Re: Chase Estates, Comprehensive Permit No. 08-18
Notice of Small Project Change

Notice of Project Change

SITE PLAN
"CHASE ESTATES" SUBDIVISION
AT
230 SANDWICH ROAD
IN
BOURNE
MASSACHUSETTS

TYPICAL ROADWAY CROSS SECTION
NOT TO SCALE

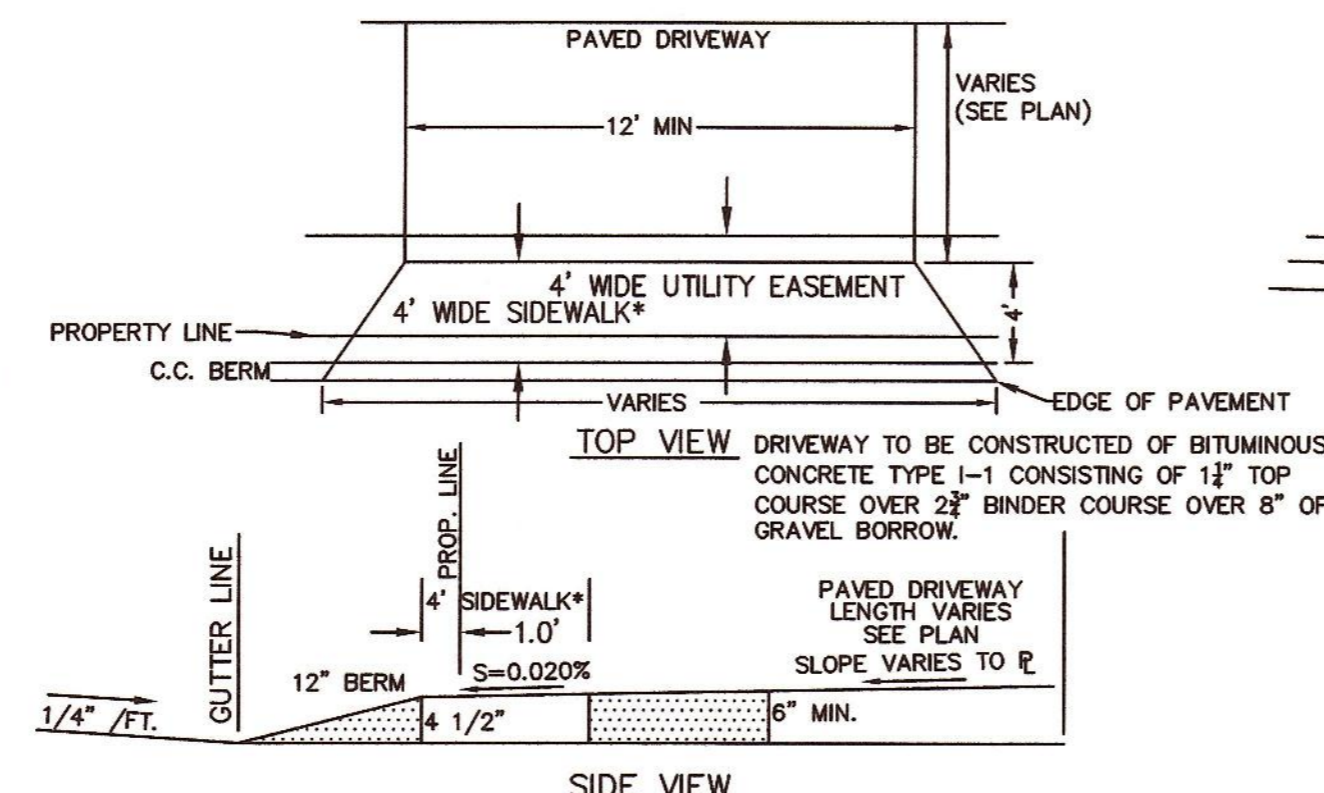
Comment 71. *“The Bituminous Concrete Pavement detail should be revised to call for 2.5-inches of concrete binder course to provide a total pavement thickness of 4-inches per Town requirement. Also revise the Typical Roadway Cross Section detail to 2.5-inches of binder.”*

TYPICAL ROADWAY CROSS SECTION
NOT TO SCALE

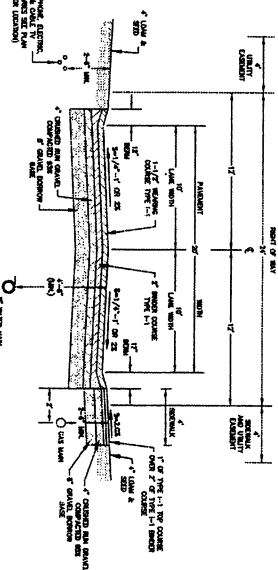
71. The *Bituminous Concrete Pavement* detail should be revised to call for 2.5-inches of concrete binder course to provide a total pavement thickness of 4-inches per Town requirement. Also revise the *Typical Roadway Cross Section* detail to 2.5-inches of binder.
